URGENT – RECALL NOTICE ON MILLER MINILITE FALL LIMITER AND THE TITAN FALL LIMITER - PRODUCT ECALLS

PRODUCTS INCLUDED IN THIS NOTICE:

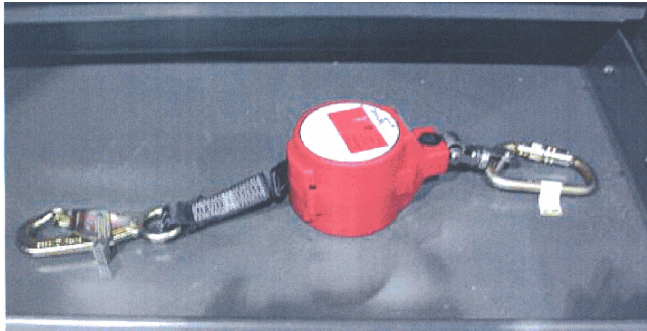
1. Remove from service all Miller MiniLite (FLII) and Titan Fall Limiter (TFL) models listed above and manufactured between August 2003 and August 2005. The date of manufacture (mm/yy) and model number are located on the product label. (Refer to figure->)
2. Contact the Miller Fall Protection Technical Service Department at 800-873-5242 to indicate that you have purchased these units. An order for replacement units can be placed at that time with the Technical Service Representative.

- A. Model number, serial number, date of manufacture for each affected unit. (Refer to figure above)
- B. Replacement product requested.
- C. Shipping instructions, i.e., company name, address, phone number, etc.
